CONVAIR

COMMERCIAL CHANGE PROPOSAL

SPEC NO.: ZD- 22-002

MODEL: 22-1 (Convair "880")

TYPICAL SECTION

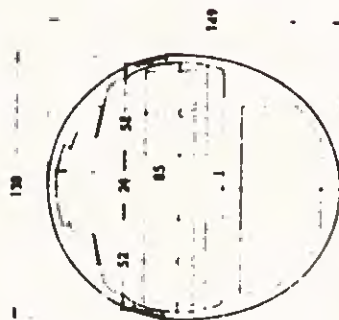
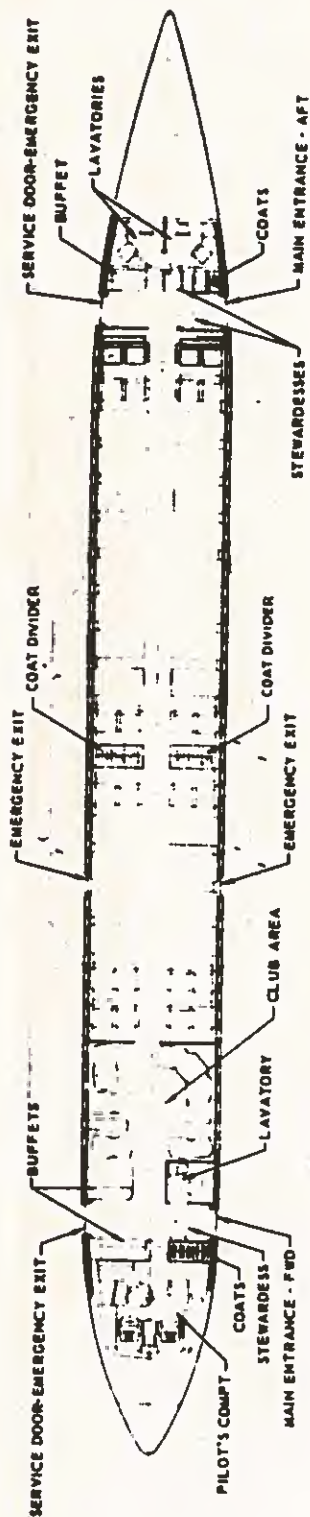
Above illustration will be revised to show movable coat dividers installed in eighth from aft row with seven triple and seven double coach installed aft of the coat dividers. The title will be revised as follows:

Page 6B, C. G. DESIGN LIMITS:

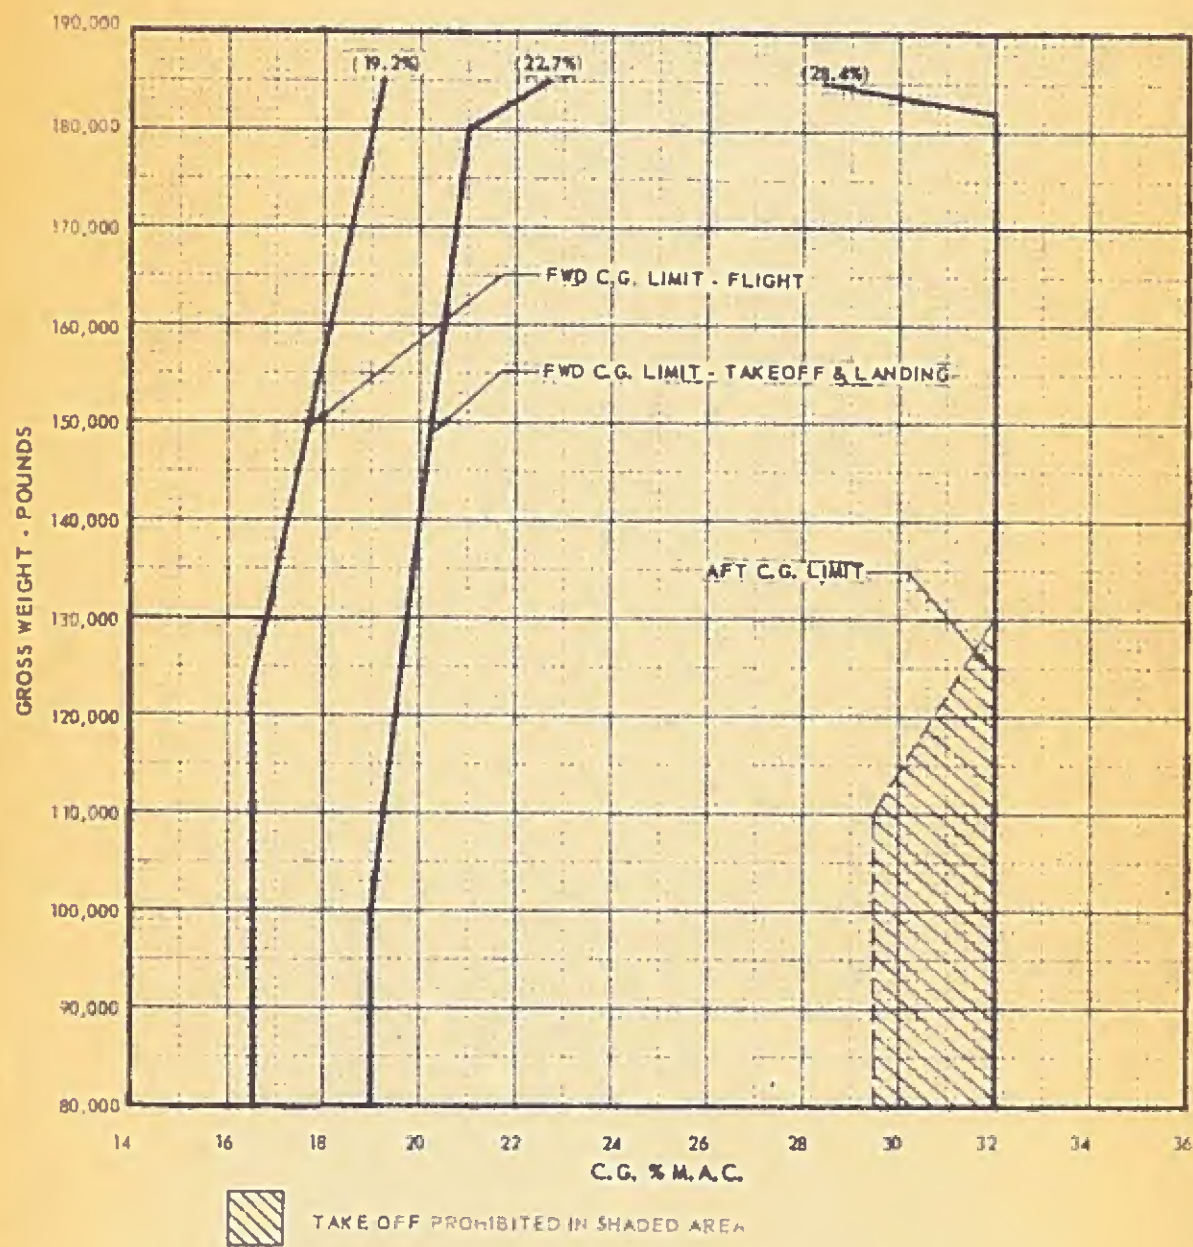
Replace above graph in specification with Enclosure (A):

Enclosure: (A) One copy Page 6B - C. G. DESIGN LIMITS (Revised)

| HEAD REST. ATTEND. | SK 22-12289-1 |

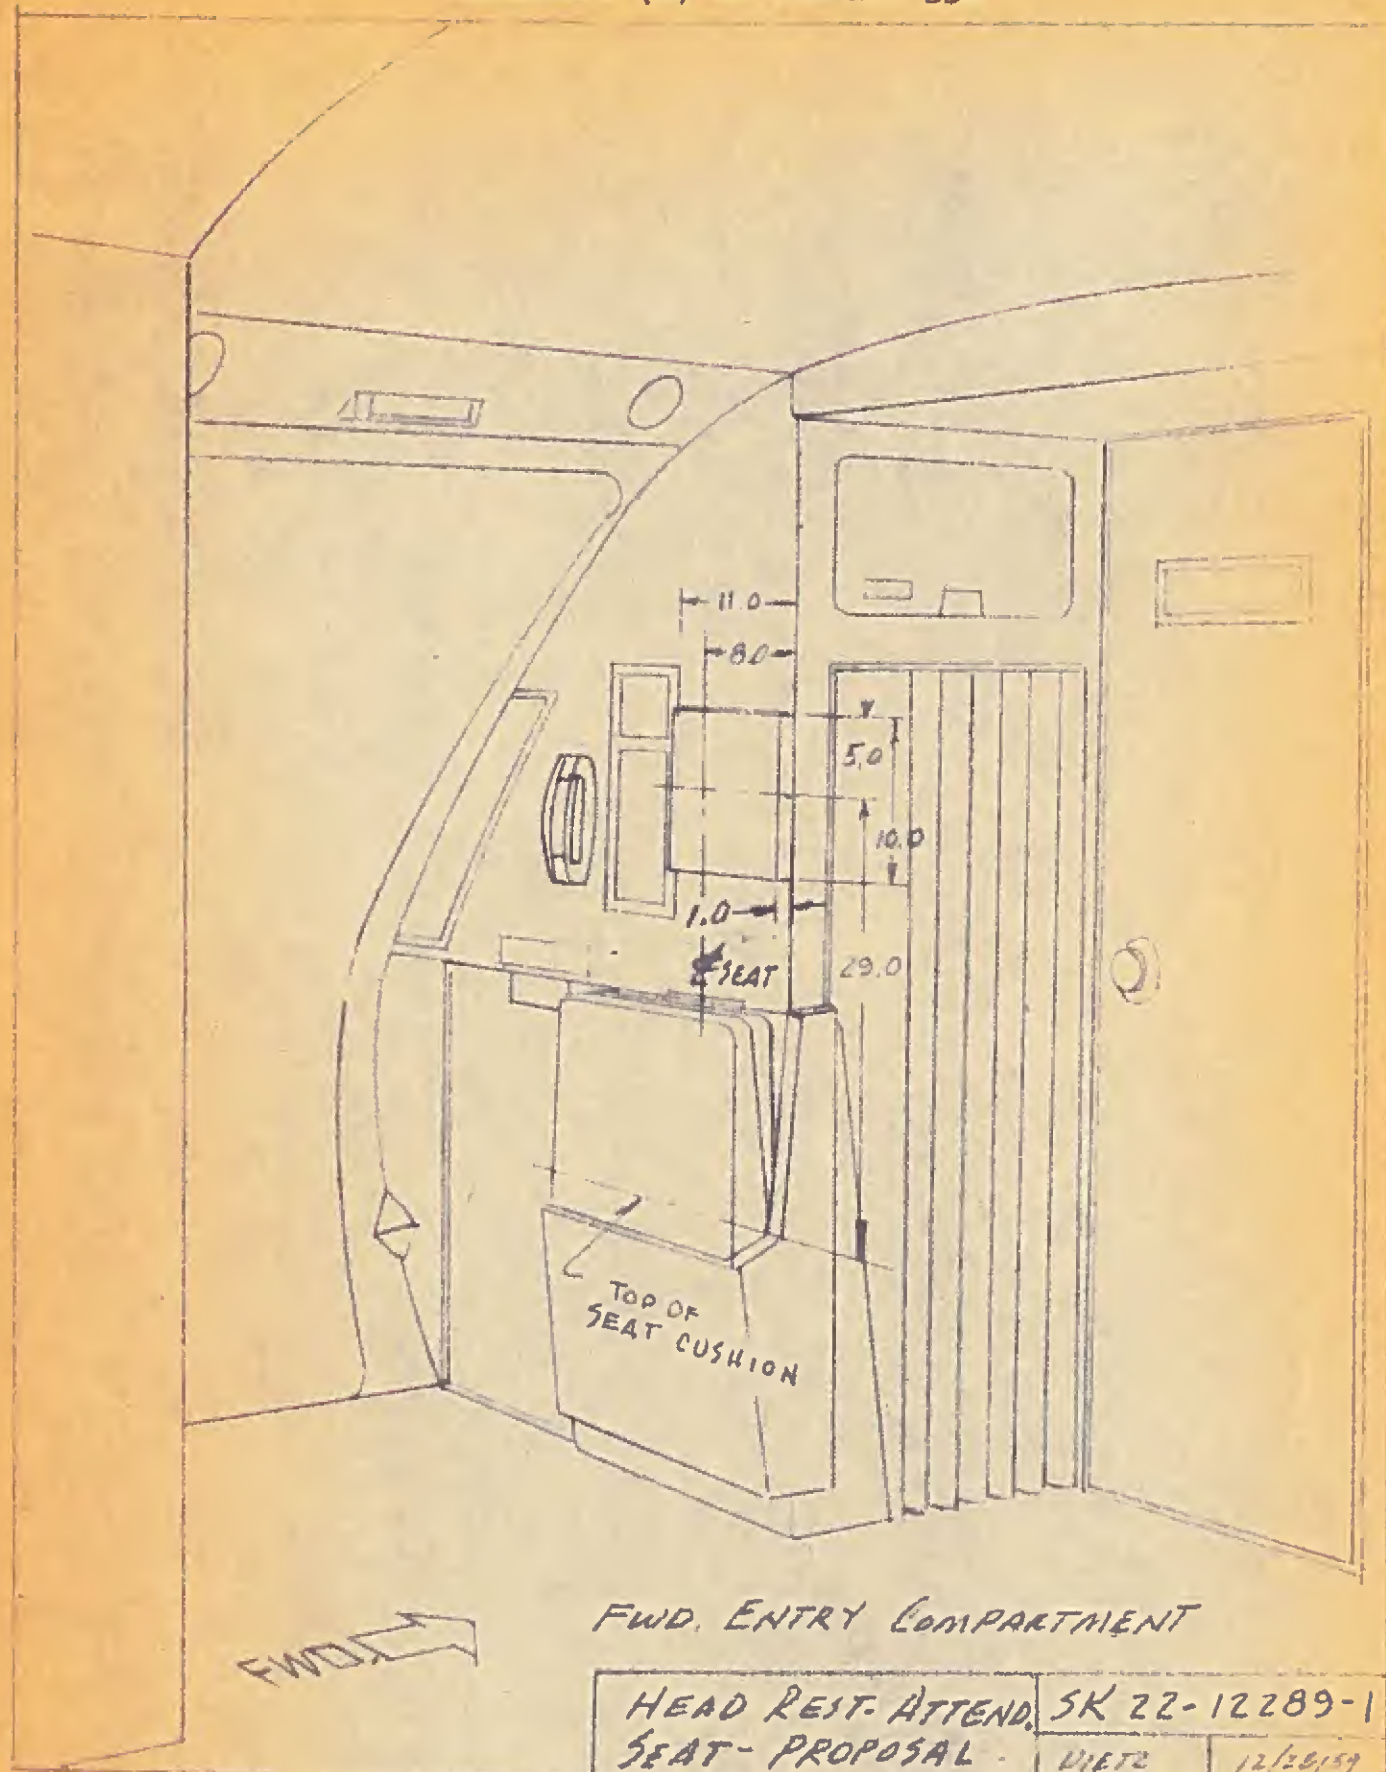
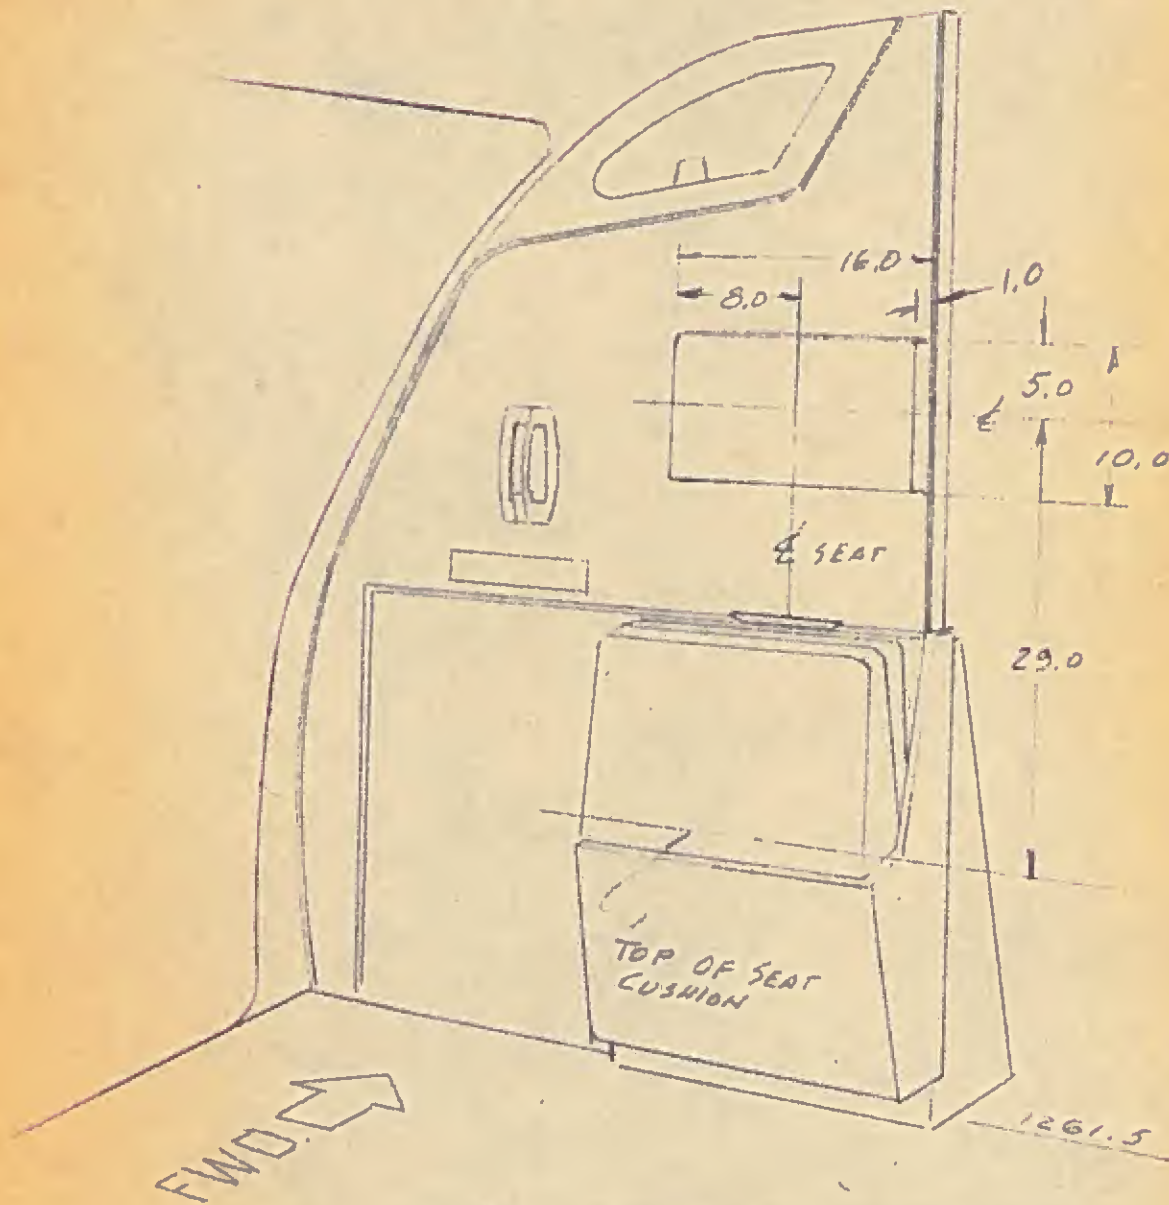
"An upholstered, detachable head rest shall be installed, one each on the aft face of the forward left hand coat compartment and on the left hand aft bulkhead for use of the aft facing cabin attendants."

ENCLOSURES: (A) Convair Sketch - HEAD REST, ATTENDANT SEAT, FWD.
ENTRY COMPARTMENT (For information only.)

(B) Convair Sketch - HEAD REST, ATTENDANT SEAT, AFT
ENTRY COMPARTMENT (For information only.)

Page 6B, CENTER OF GRAVITY LIMITS

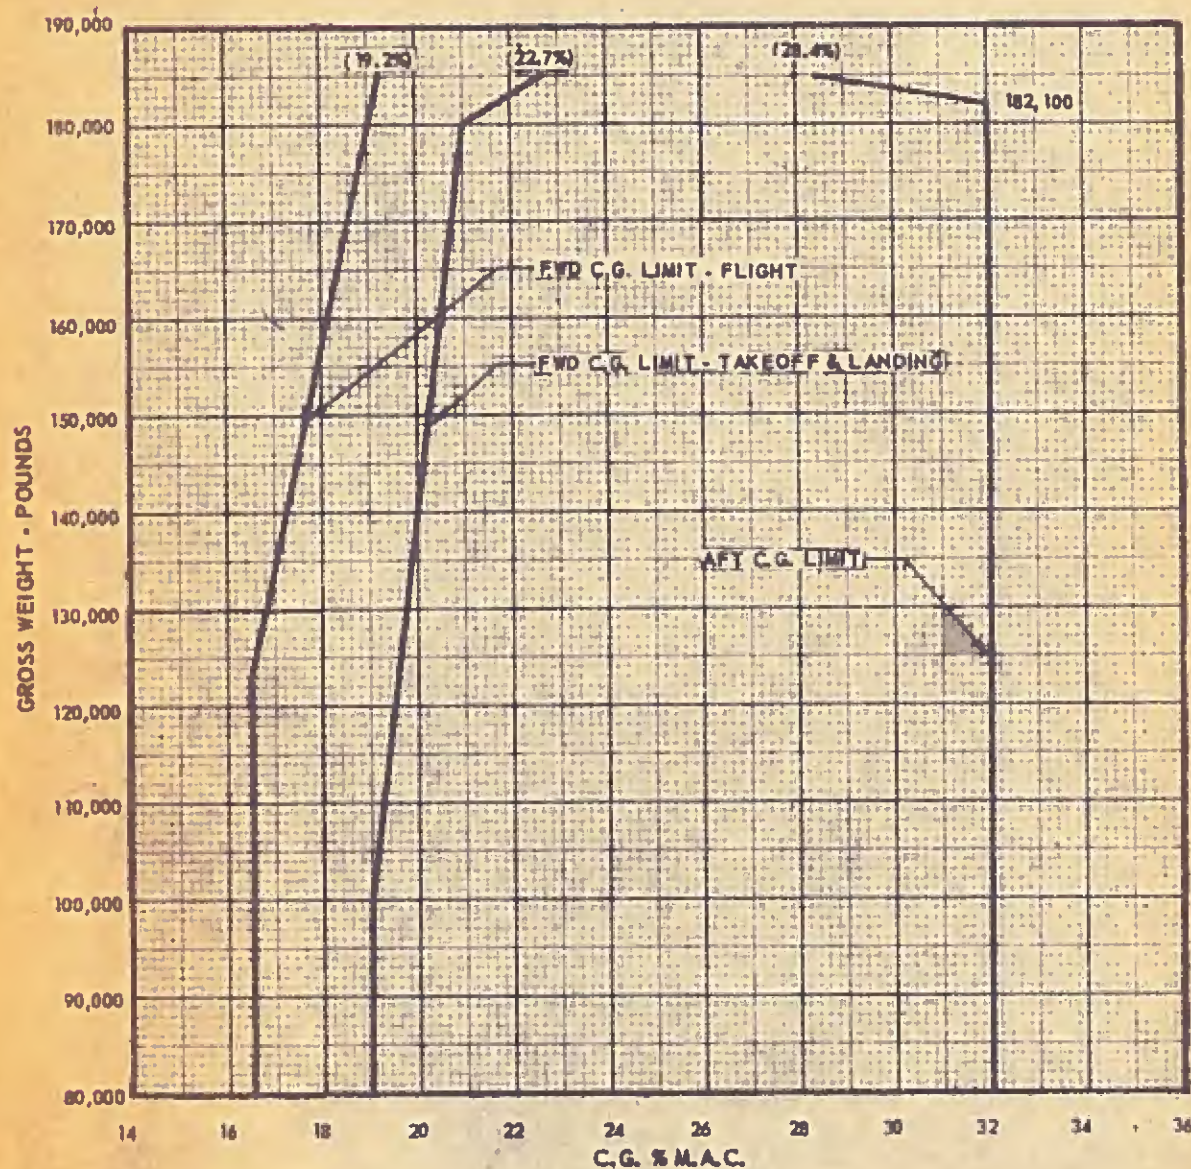
Reason for Change: To incorporate an up to date Center of Gravity Limits Graph into specification.

Enclosure: (A) One copy Convair Sketch - 52" SEAT (For information only)

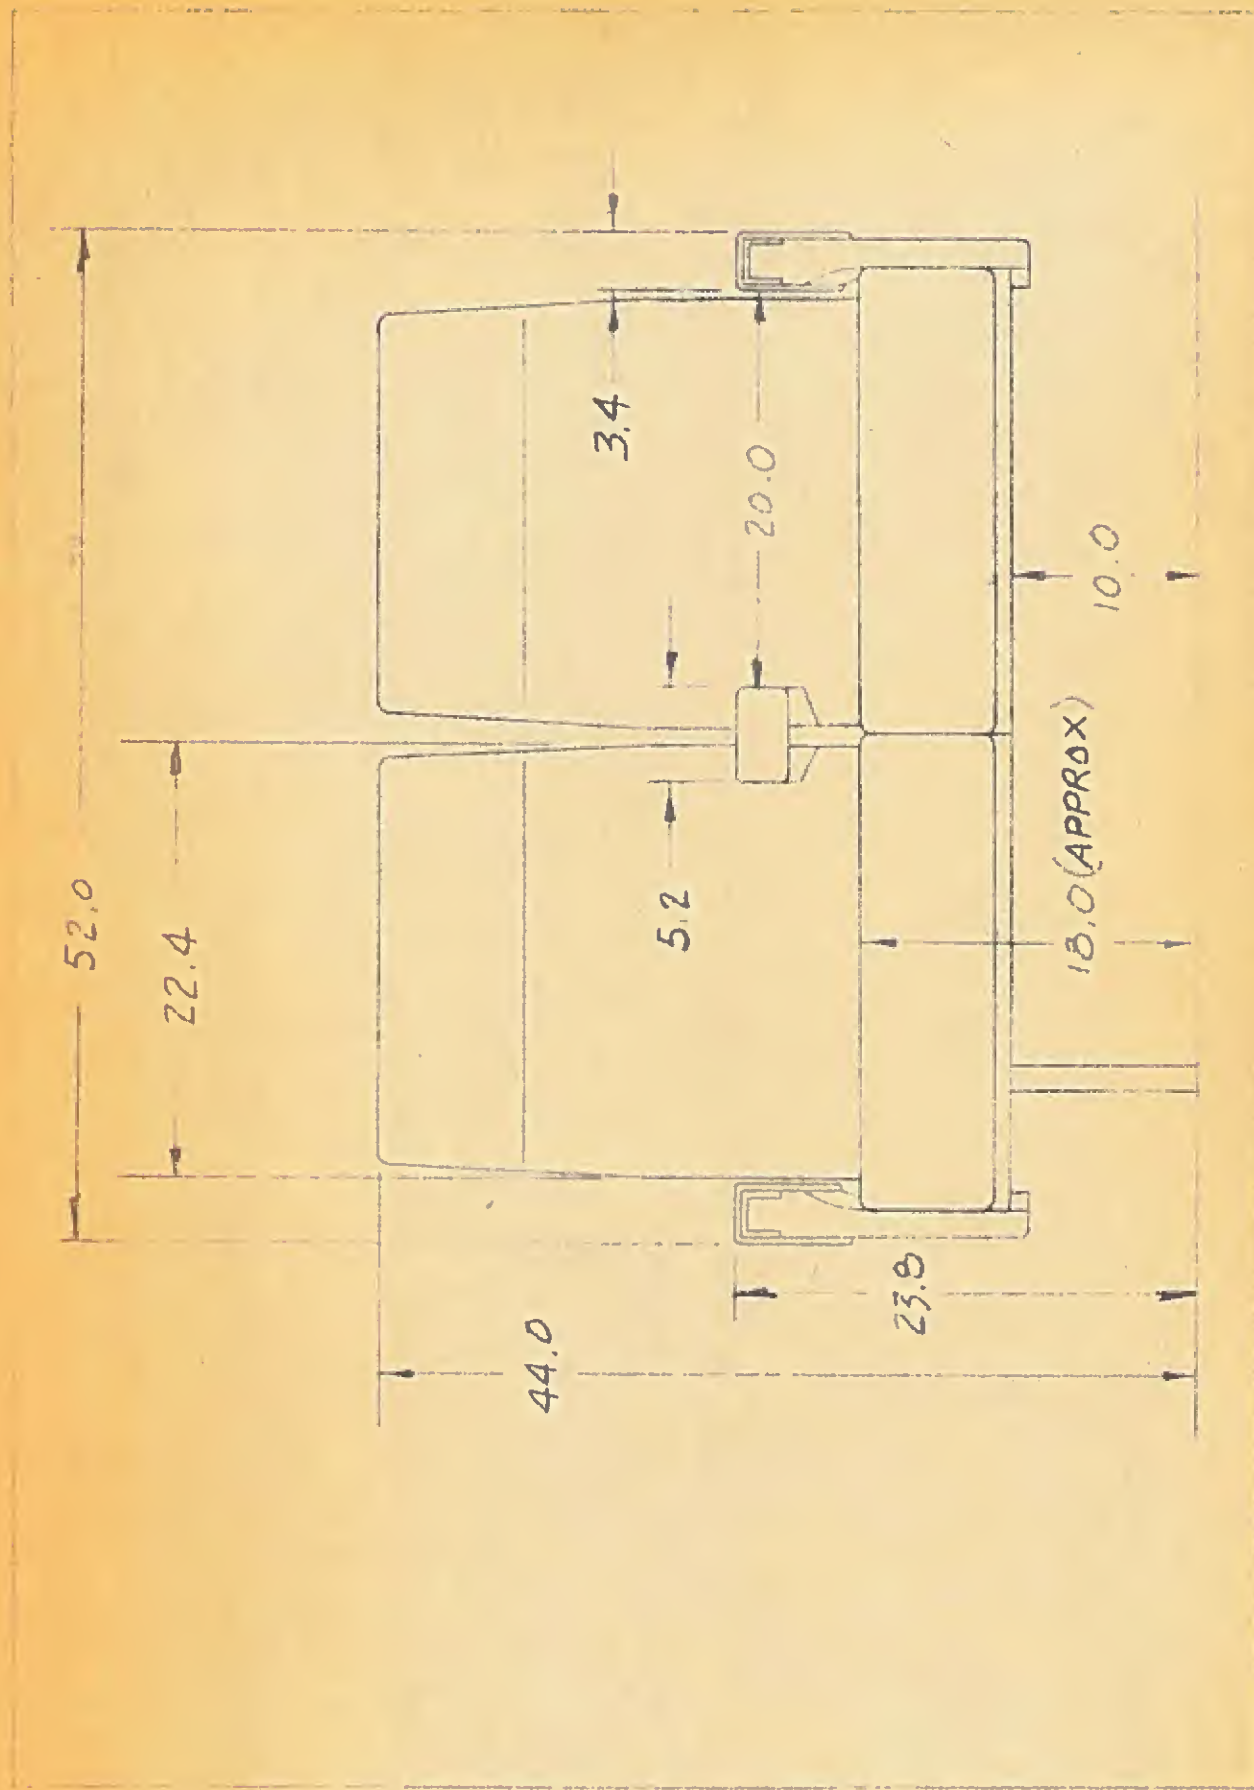
"**NOTE: Seat back covers are interchangeable between all L.H. and R.H. double-seat positions. Seat covers are interchangeable between corresponding positions on L.H. and R.H. double seats."
